ADDENDUM NO. 1

Date: **February 27, 2023**
Issued by: **Sacramento City Unified School District**
Project: **Project #0363-409 Theodore Judah ES Paving Repairs**

1 OVERALL ARCHITECTURAL SITE PLAN
1" = 30'-0"

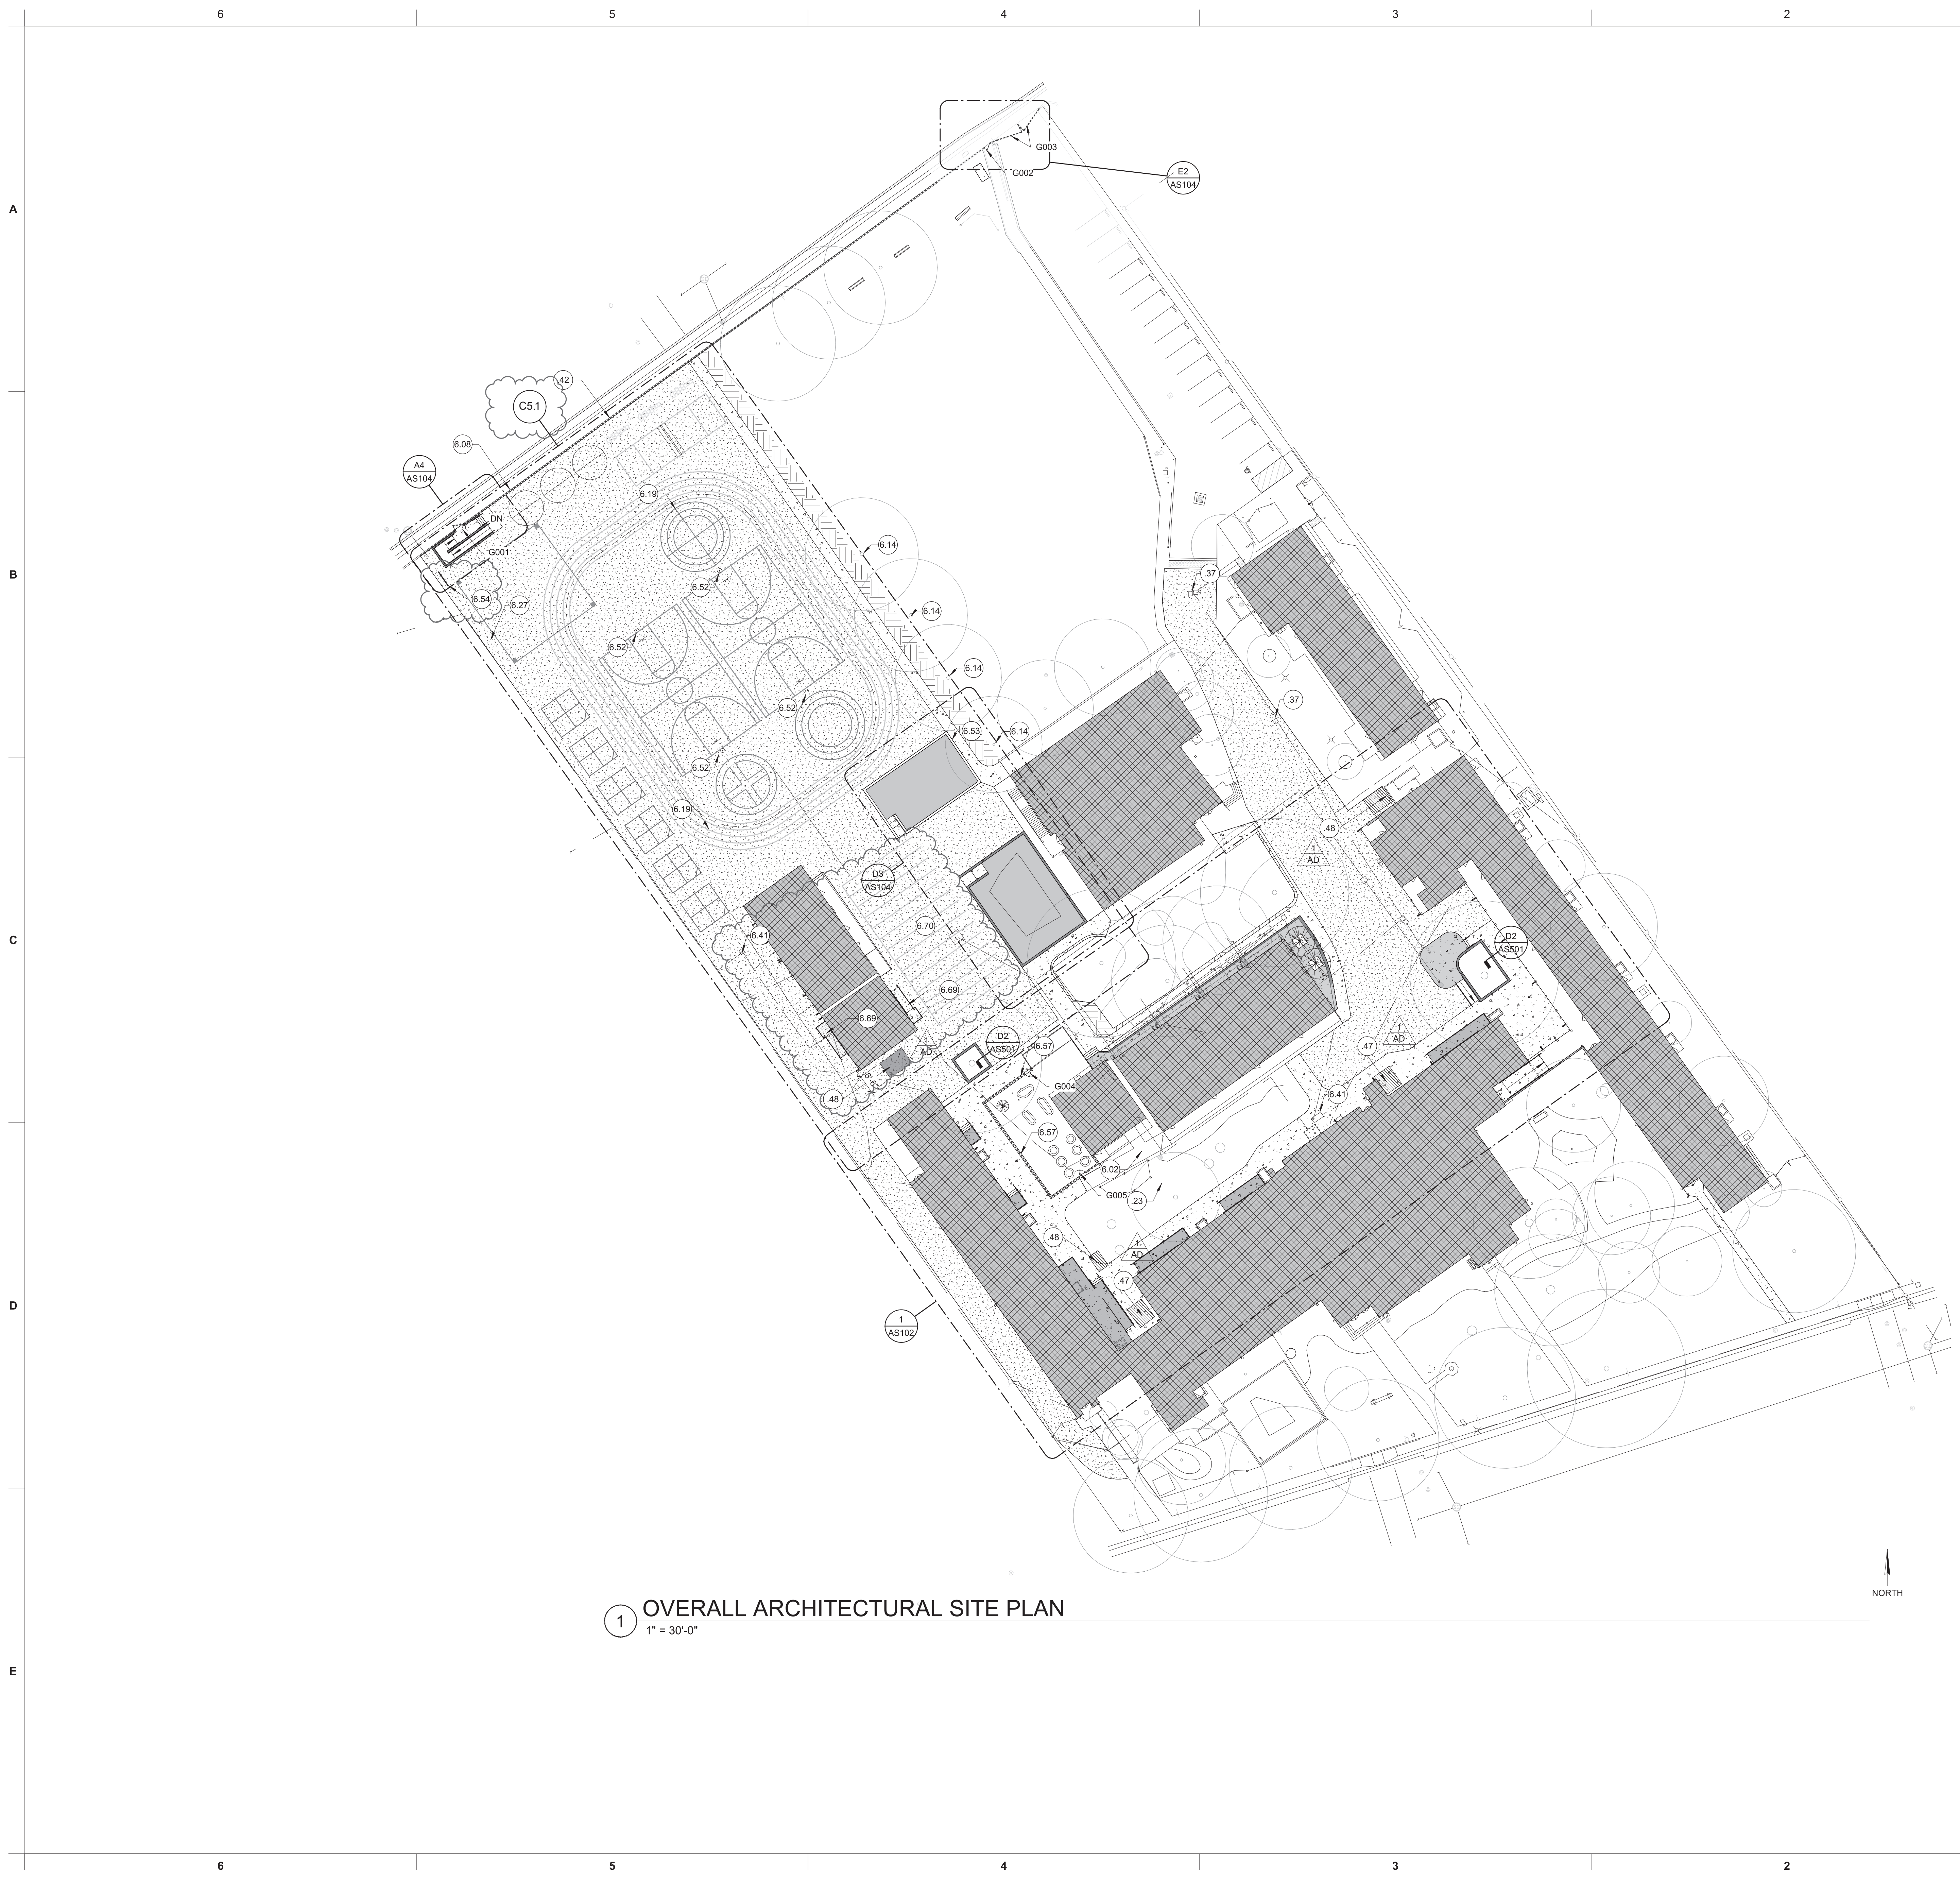
Q4: The plans contain a reference to sheet AS105 for the hardcourt, but it appears that sheet AS105 is missing from the drawing set. Please provide drawing AS105.

Q5: AS101 keyed note #6.52 references detail (D5/GS502) for the basketball pole. Drawing GS502 appears to be missing from the drawing set. Please provide drawing GS502.

A4: There is no Sheet AS105 in this project. All striping is shown on Sheet C5.1. Refer to attached ADD1 AS101.

A5: Refer to attached Sheet ADD1 AS101.
